TOWN OF MONONGAH MARION COUNTY, WEST VIRGINIA

CONTRACT #2 – PROPOSED TWO (2) NEW 530,000 GALLON WATER STORAGE TANKS AND ONE (1) NEW 183,000 GALLON WATER STORAGE TANK

ADDENDUM #2

Thrasher Project #101-010-0924

WELDED STEEL TANK DETAILS

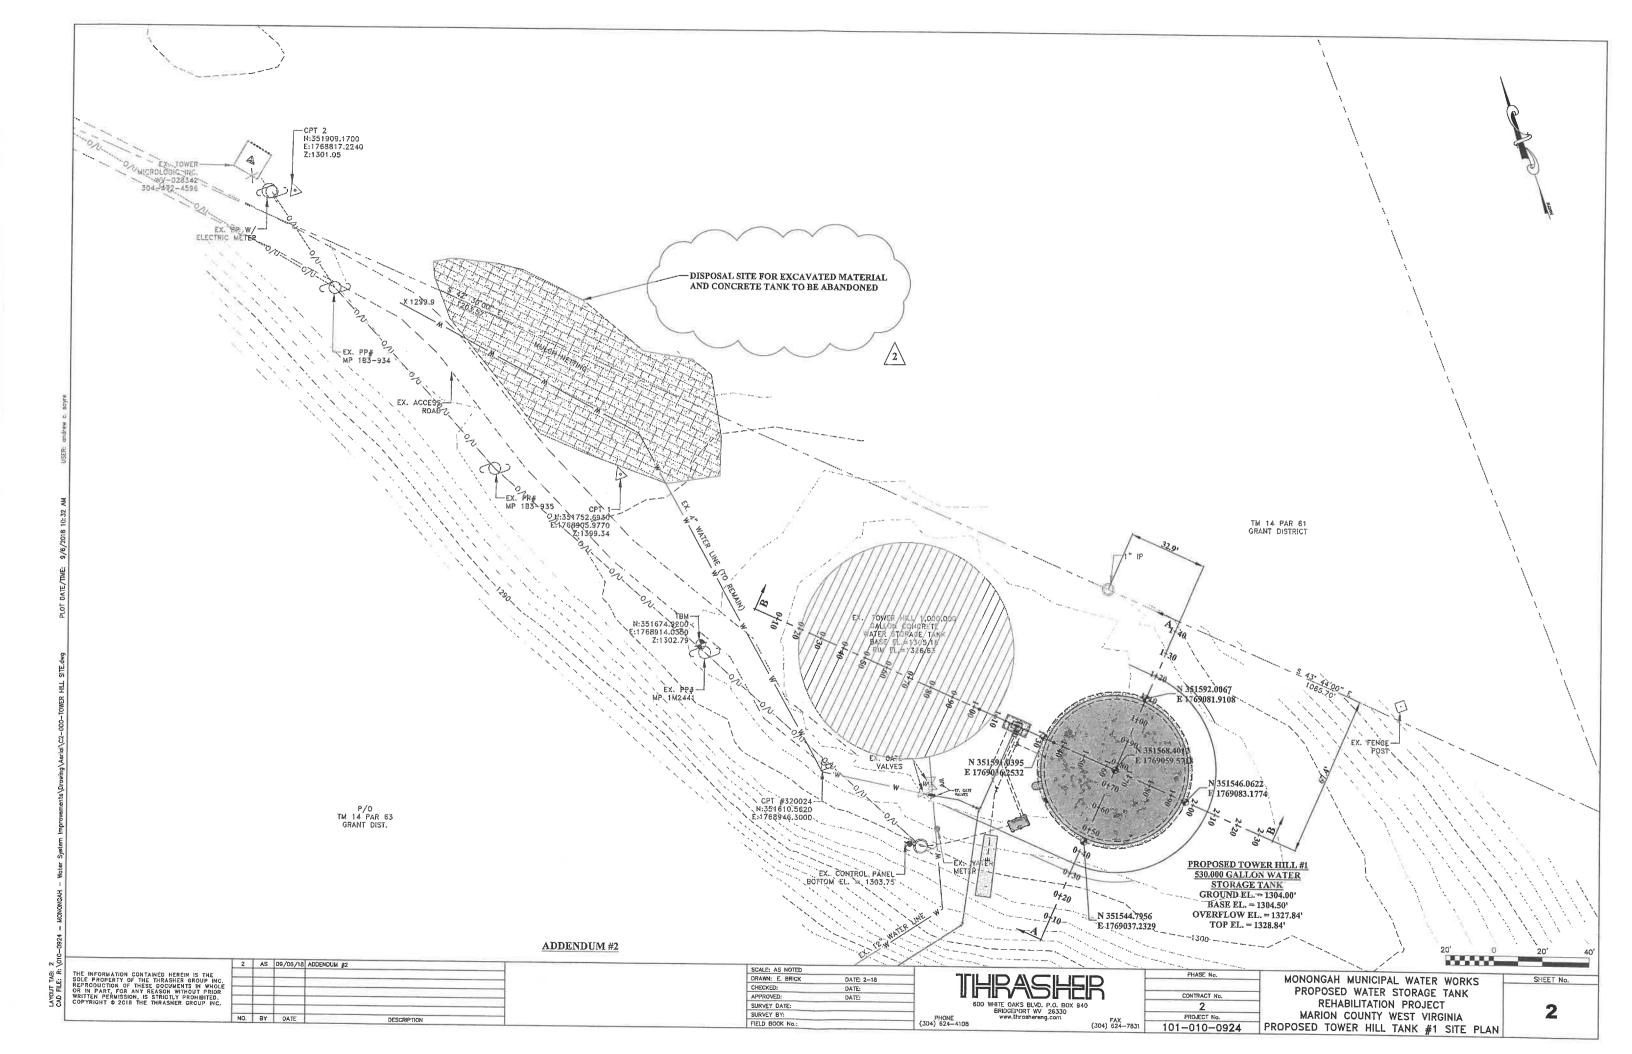
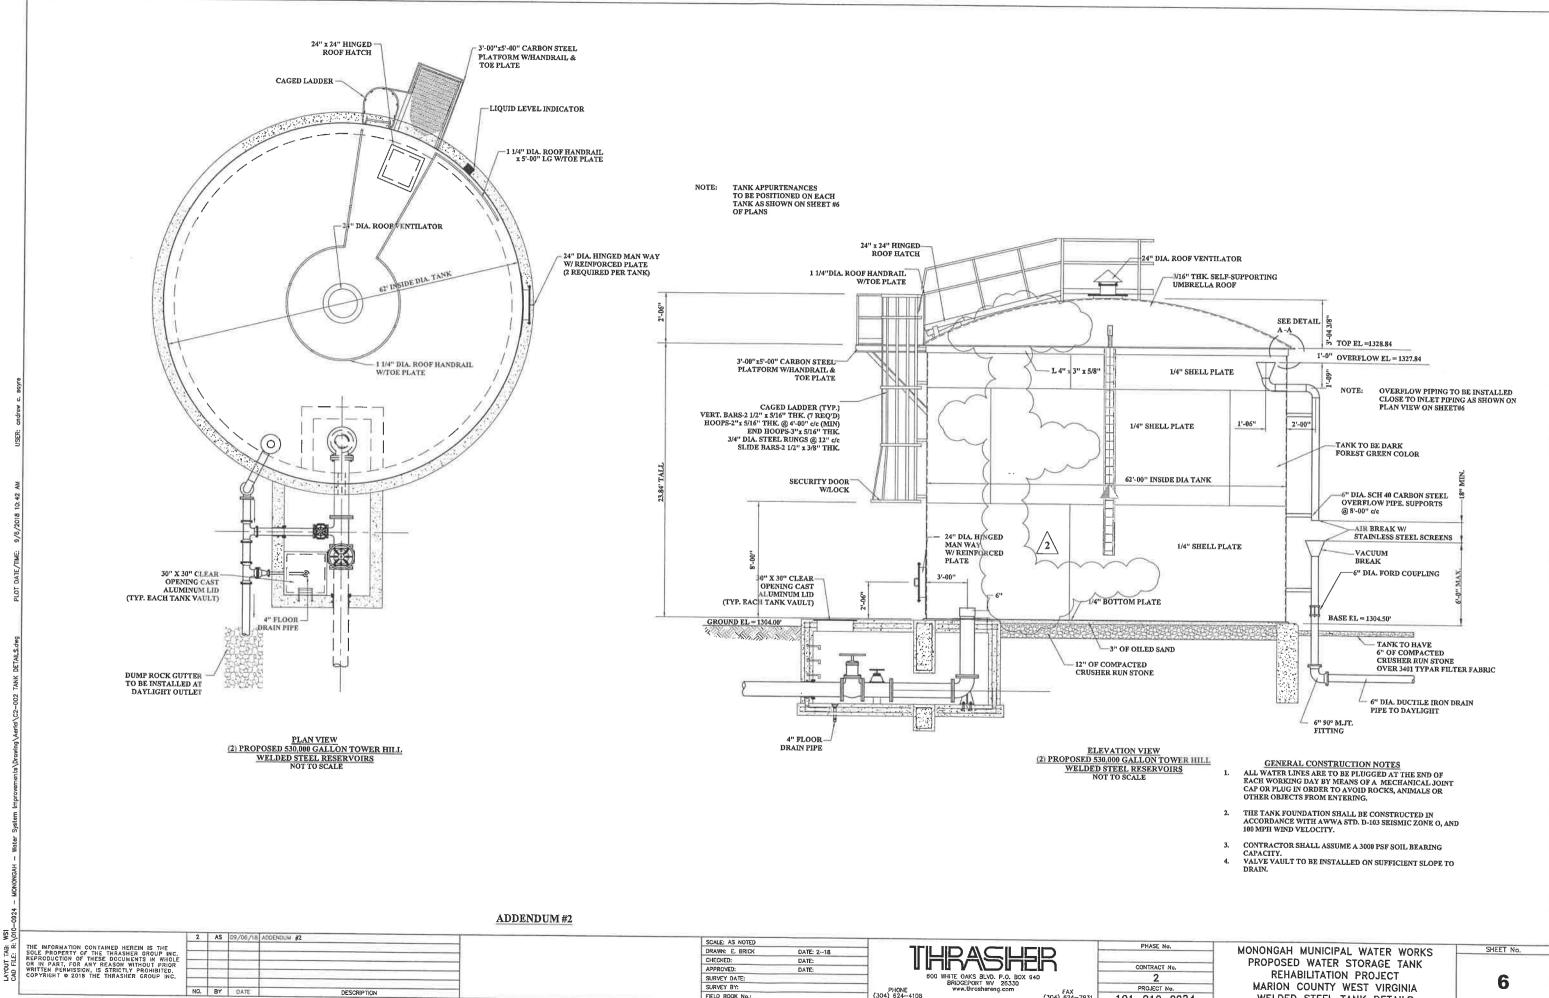
4. On plan sheets 6 and 9, there are references to a Gridbee tank mixer on the drawings, but no information in the specifications or bid form. Can you clarify and provide a specification if needed?

Tank mixers are not required for this contract. Plan sheets 6 and 9 have been revised to remove the mixers, chains, and electrical items. The revised plan sheets have been included with this Addendum.
